Technical Service Bulletin: TSB130044	Released Date: 01-Apr-2019
New Fuel Pump Gear Pump with Revised Fuel Line Locations

New Fuel Pump Gear Pump with Revised Fuel Line Locations

Figure 1, Top Port Pump Gear Pump with Revised Fuel Line Locations.

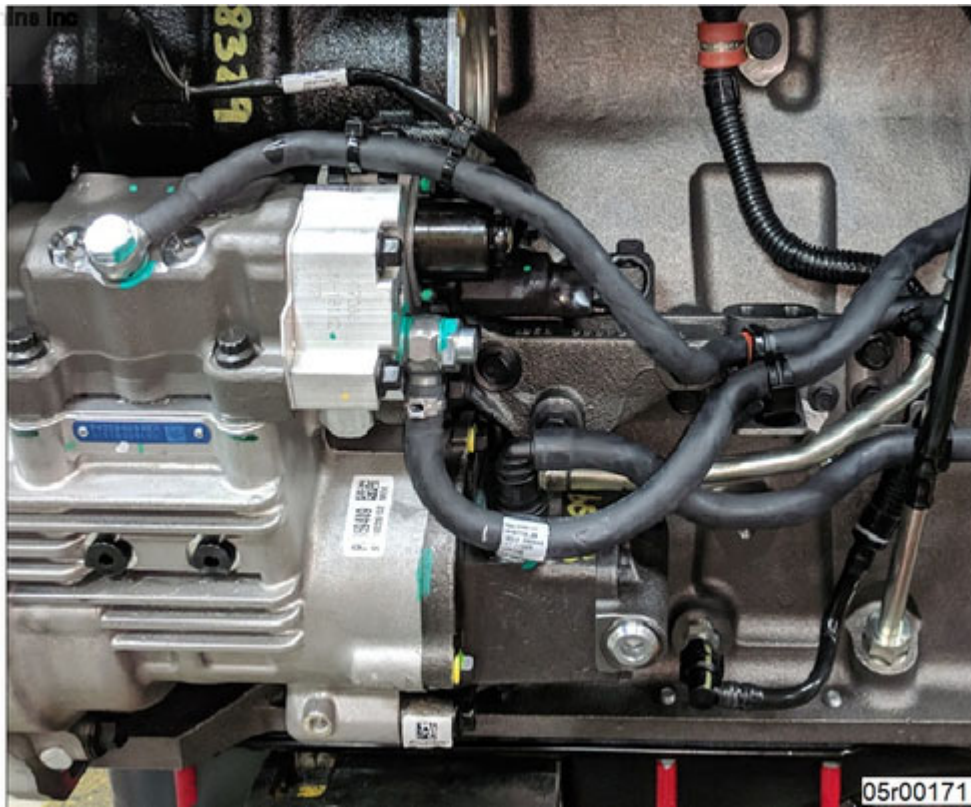
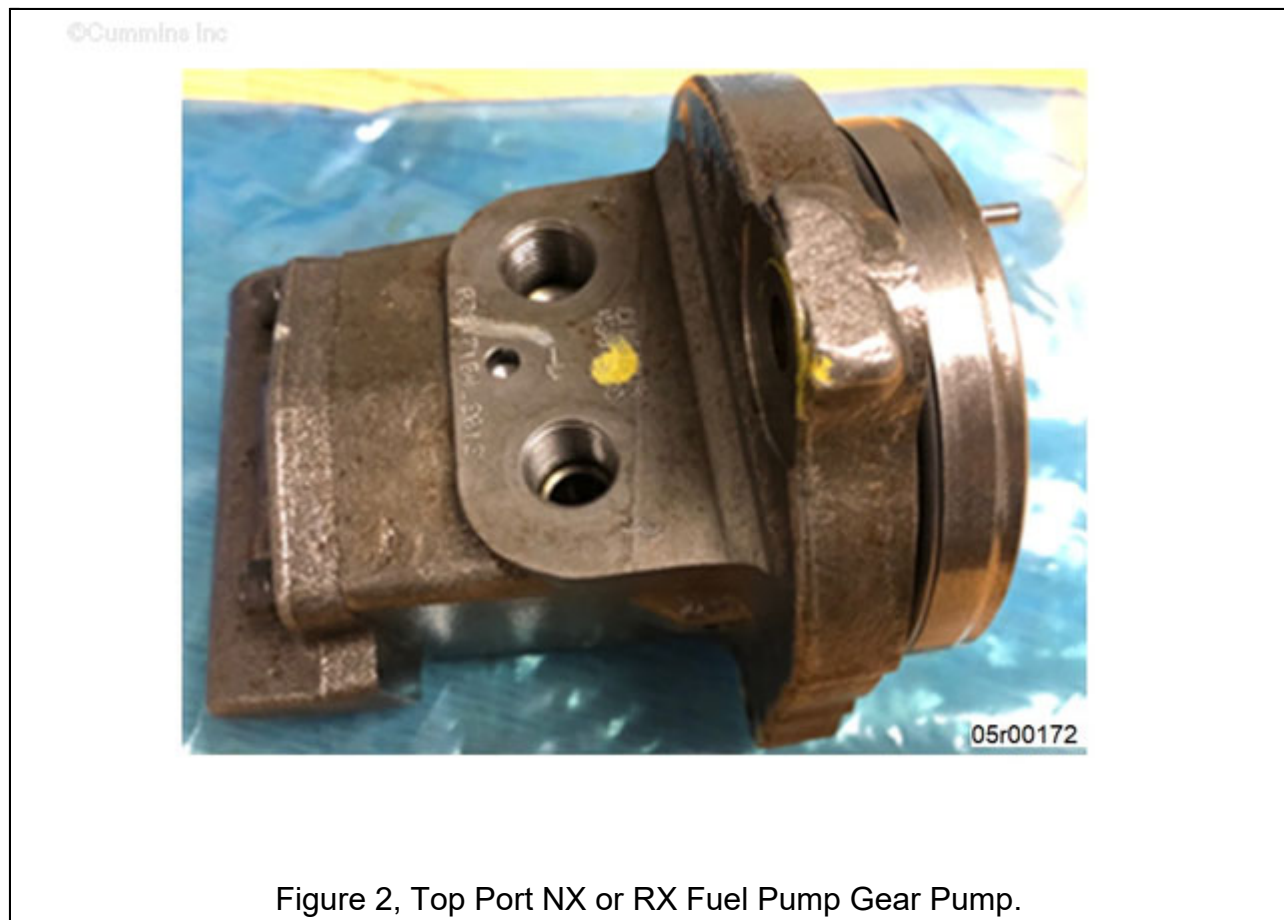
- Engines were released with the fuel lines located on the bottom of the fuel pump gear pump.
- A new design fuel pump gear pump has been released with the fuel line location changed to the top of the fuel pump gear pump. See Figure 1 and 2 below.

- Upgraded fuel lines were released accordingly.

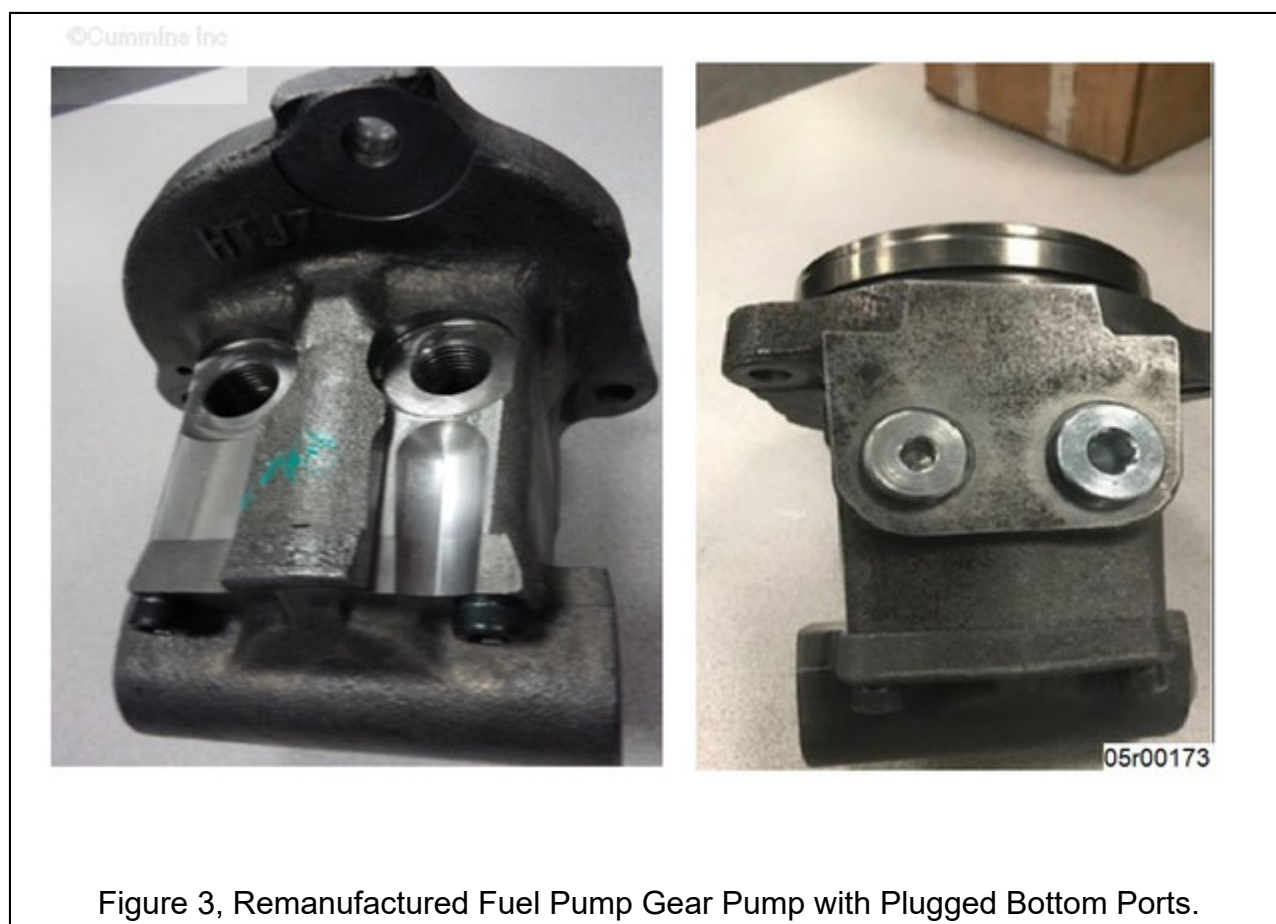
- Fuel pump gear pumps with original bottom fuel line ports have been remanufactured to introduce an upper fitting location; required for top fuel supply tube plumbing. The bottom ports on the fuel pump gear pump have been plugged. See Figure 3 for visual representation.

Do not relocate O-ring threaded plugs to top of fuel pump gear pump. Removal of O-ring threaded plugs from fuel pump gear pump assembly will result in external fuel leaks.
